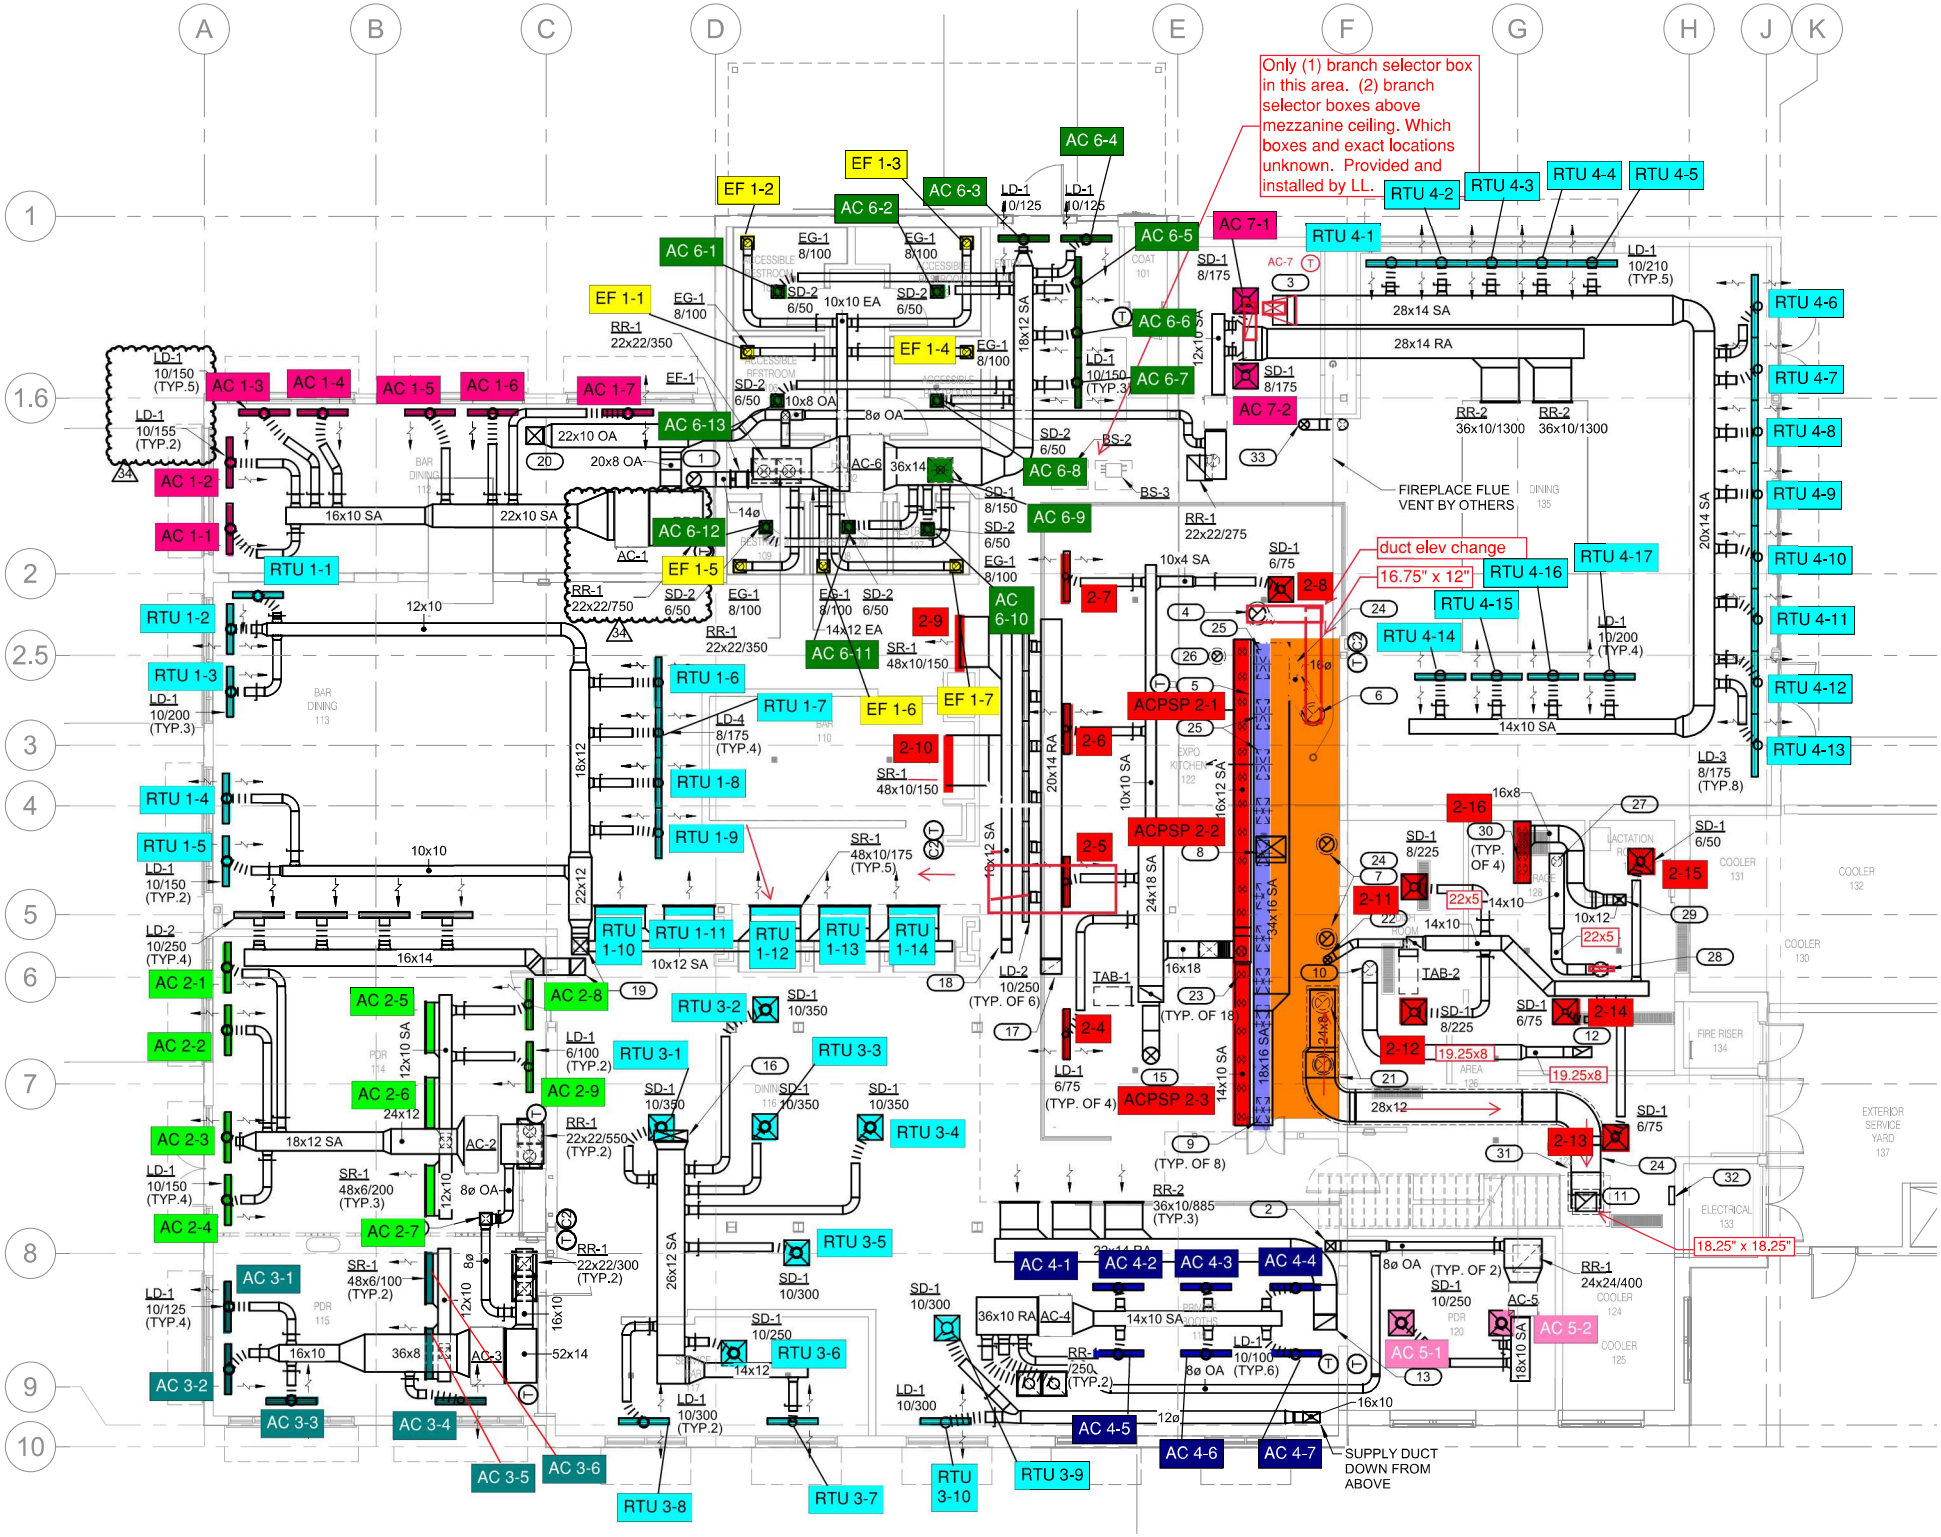
Only (1) branch selector box in this area. (2) branch selector boxes above mezzanine ceiling. Which boxes and exact locations unknown. Provided and installed by LL.
duct elev change
